Monitoring Report – MY5
FINAL VERSION
Lake Wendell Mitigation Project
Calendar Year of Data Collection: 2022

NCDEQ DMS Project Identification # 97081
NCDEQ DMS Contract # 6826
Neuse River Basin (Cataloging Unit 03020201)
USACE Action ID Number: SAW-2016-00876
NCDEQ DWR Project # 2016-0385 V2
Johnston County, NC
Contracted Under RFP # 16-006477
Data Collection Period: March & September 2022
Submission Date: November 30th, 2022

RE: WLS Responses to NCDEQ DMS Review Comments for Task 11 Draft Monitoring Report Year 5 for the Lake Wendell Mitigation Project, NCDEQ DMS Full-Delivery Project ID #97081, Contract #6826, Neuse River Basin, Cataloging Unit 03020201, Johnston County, NC

Looking Downstream

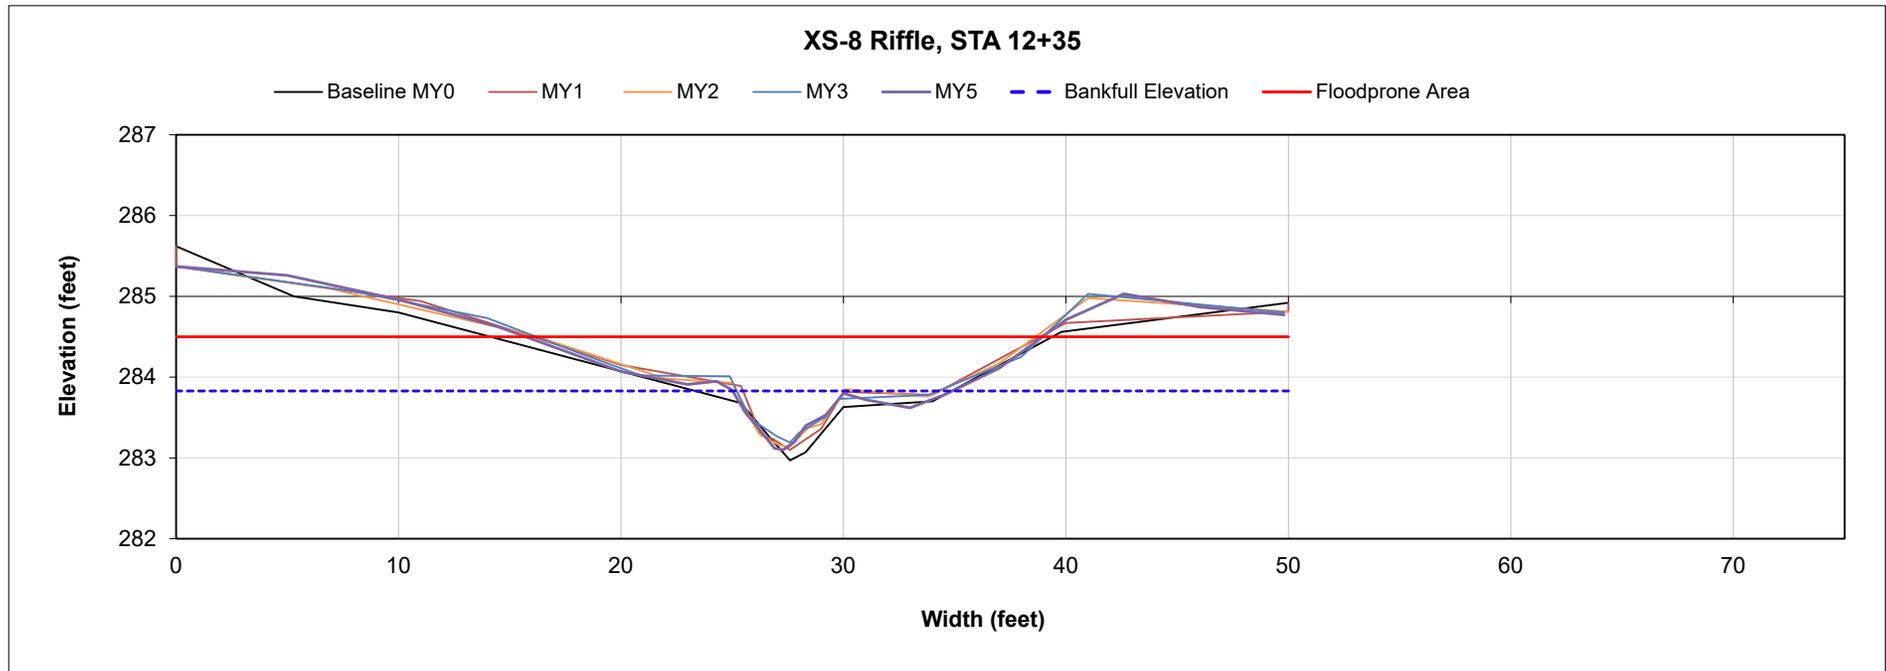
5. **Section 5.2 (p.7) and Figure 2 geomorphic tables and MY5 Cross-sections: The 2016 guidance establishes that BHR should not exceed 1.2 or 10% change per year at any measured riffles, but this does not apply to pool cross-sections. Suggest removing BHR and % change BHR from riffle tables. Consider also revising narrative on p. 7 referring to these changes in pools, which appear to be natural geomorphologic processes for this site.** WLS Response: Language on page seven was updated to remove pool cross-sections and corresponding BHRs. Pool BHR was removed from the riffle table.

FIGURE
1

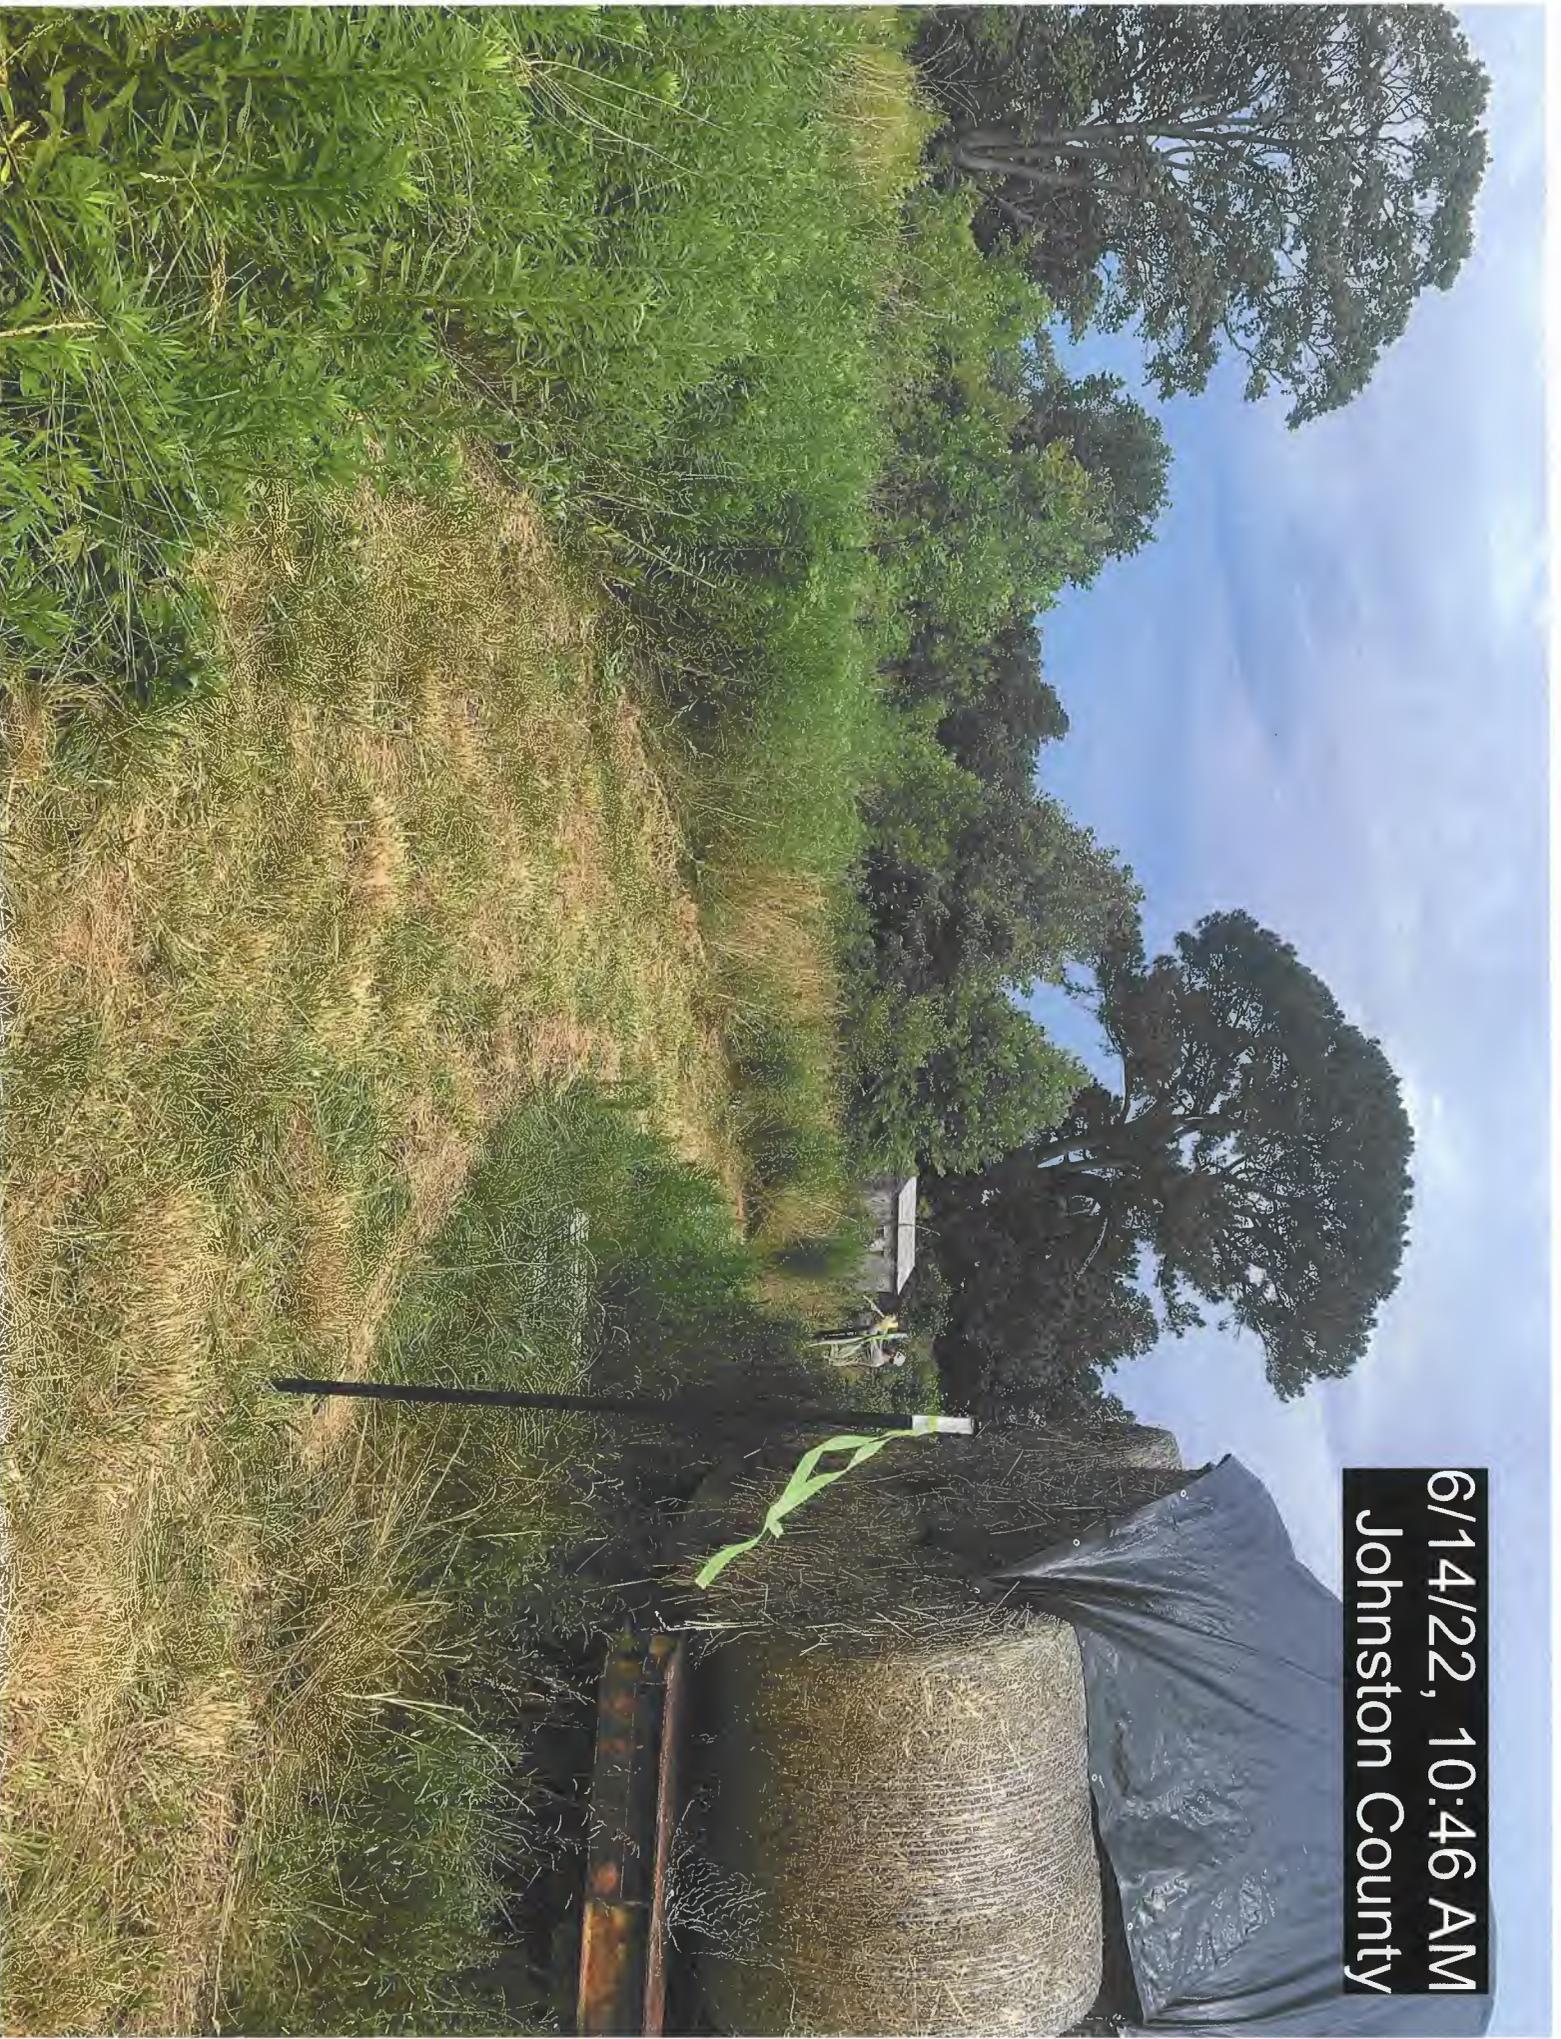
2. **There are multiple vegetation problem area photos submitted but only a single location indicated on the CCPV, please verify these photos are located in the area depicted on the polygon shape submitted.** WLS Response: Two vegetation problem areas are on the CCPV, VPA 1 and VPA 3. Photos of both areas are included in the e-data folder. Since VPA 2 was removed from the CCPV as a problem area, photos of VPA 2 were removed from the submittal folder.
